Minutes of Pre-Bid Meeting held on 21/11/2016 at 04:00PM Regarding Tender Enquiry No.: 09/CCMD/2017-17 dated 28-10-2016 for Supply, Erection, Testing and Commissioning 2 No. of 2000KVA , 11KV Diesel Generator sets.

The following are the questionnaires from representatives and clarifications from the institute-

S.L.D FOR D.G POWER DISTRIBUTION

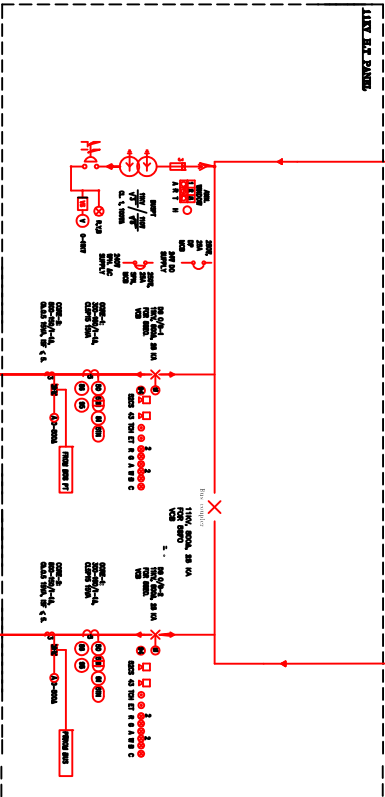
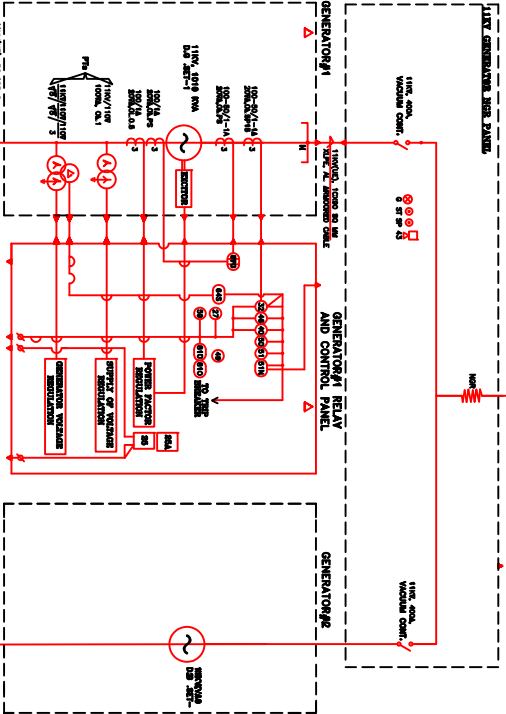
15.	SLD	SLD Enclosed.
